Before the Federal Communications Commission Washington, D.C. 20554

In the Matter of)	
MDS OPERATIONS, INC.)))	Call Sign WQAR561, MVD049 - Albuquerque-Santa Fe, New Mexico
Request for Waiver of Certain Multichannel Video)	• •
Distribution and Data Service Technical Rules for)	WT Docket No. 07-255
One Station in Sandia Park, New Mexico)

ORDER

APPENDIX
Prior-approval Area

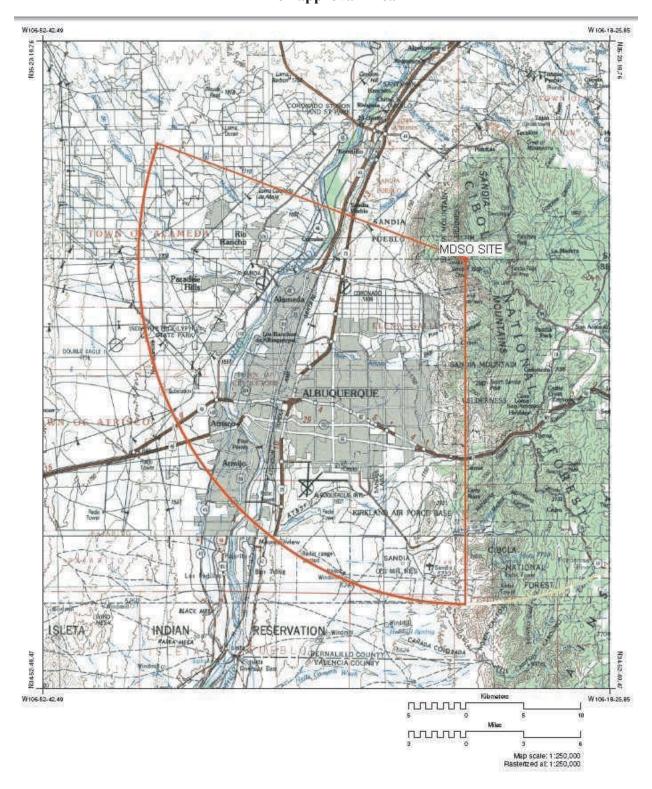
- MDS Operations shall not deploy any additional transmitting antennas (including facilities that meet the Commission's Rules) in the Albuquerque-Santa Fe MVD located less than 30 km (18.6 miles) from the Sandia Park site between the radials 180° and 290° from True North (the "prior-approval area") without applying for and obtaining prior site-specific authority from the Commission,
